SAFETY ADVISORY # 15-225**Norco Cable Bracket**

Keystone RV Company is conducting a voluntary RECALL notification campaign in accordance with the National Traffic and Motor Vehicle Safety Act. It has been decided that the self-tapping screws attaching the Norco slide room cable bracket to the drive chain may fail. If all four (4) screws for the cable brackets holding the room in the closed position fail, the slide room will not be secured to the sidewall during travel and the slide room may extend increasing the risk of vehicle crash. This advisory explains how to replace the fasteners.

Fig. 1

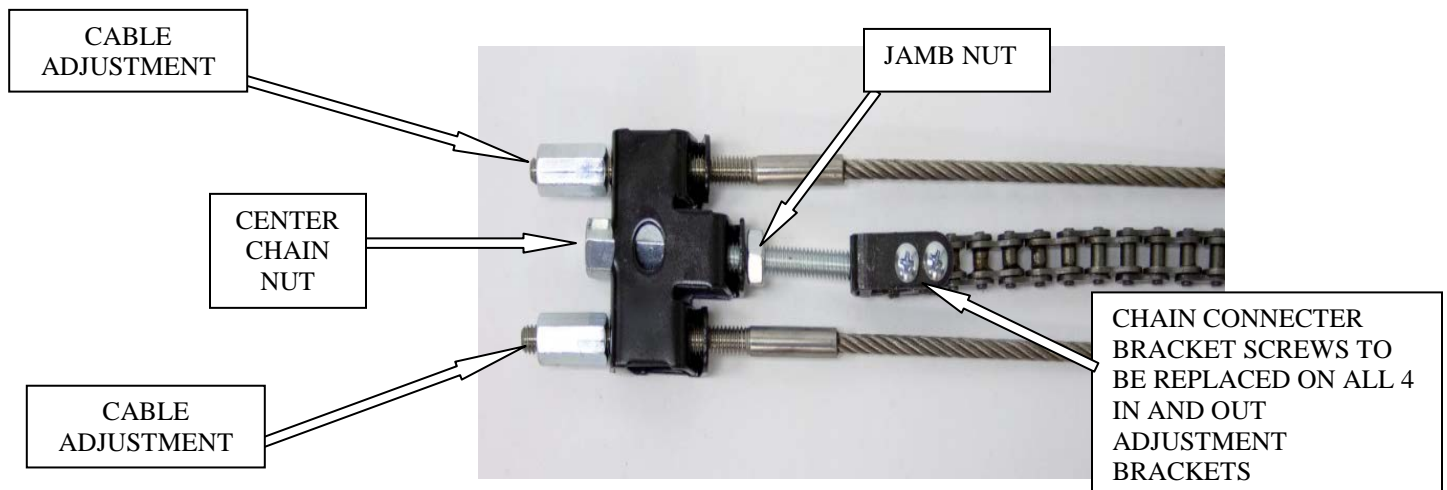
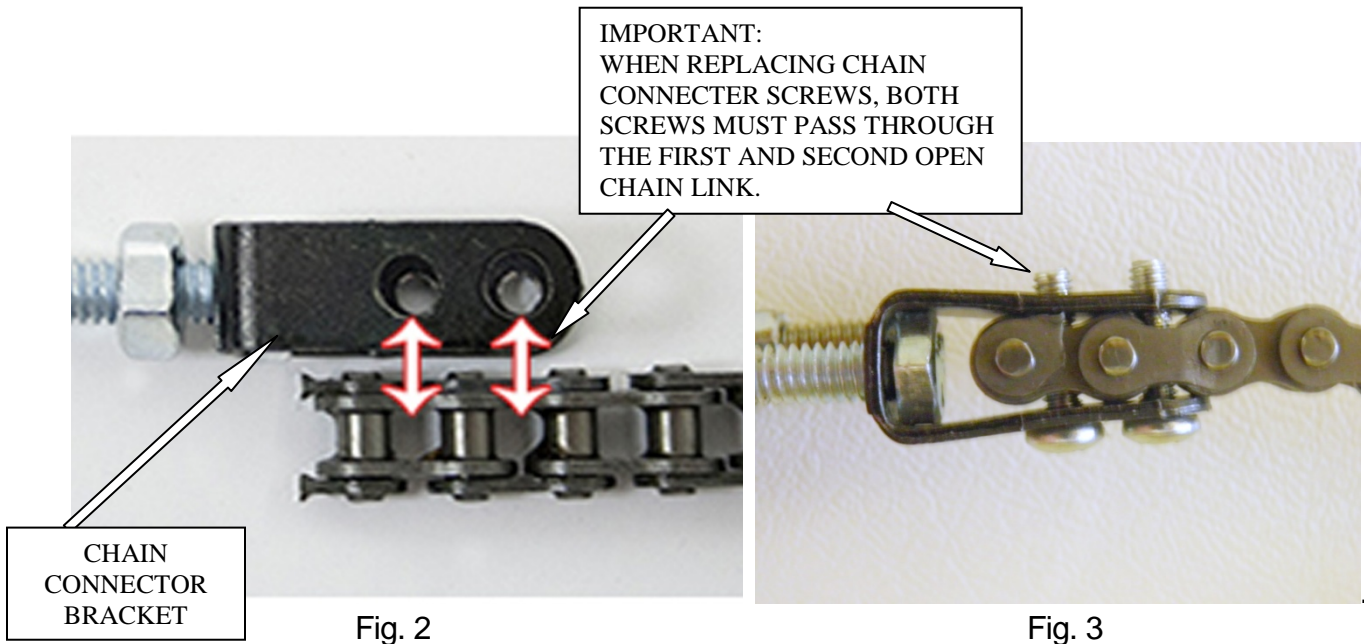
- Step 1** Locate the trailer on a level, flat and hard surface. Chock the wheels.
- Step 2** Extend the slide room to the out position. From the exterior, properly support the room.
- Step 3** Using standard industry practices, remove the interior slide room fascia to gain access to the cable adjustment brackets.
- Step 4** Loosen all center chain nuts (all 4 in and out adjustment brackets), leaving the jamb nuts and cable adjustment nuts in place. See Figure 1.

- Step 5** At the chain connector bracket, remove one screw at a time and replace it with a new screw. If the bracket is damaged or bent, take a picture of the bracket, remove the chain nut and replace with the supplied chain connector bracket. See figure 2 & 3. Tighten both the screws. Repeat the screw replacement for both screws of all 4 chain connector brackets.
